May 6, 2026

Town of Jackson Planning Commission
200 S Willow St
Jackson, WY 83001

Re: Town of Jackson Draft Wildlife Friendly Fencing LDR AMD

FENCING ADJACENT TO A SWALE GULLY OR DROP IN ELEVATION

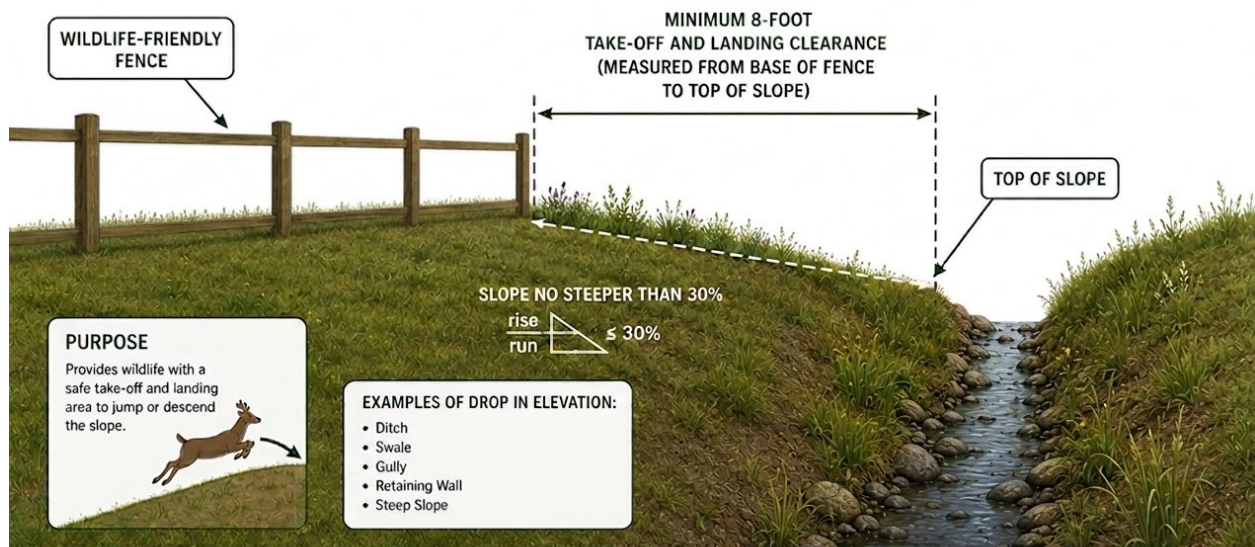
To help improve interpretability of section 5.1.2.F, we recommend including a graphic, similar to the one attached below.

A minimum 8-foot take-off and landing clearance area shall be maintained with a slope no steeper than 30% between the fence and the top of slope.

- Maintain a minimum 8-foot horizontal clearance from the base of the fence to the top of slope.
- The slope within this clearance area must be no steeper than 30%.
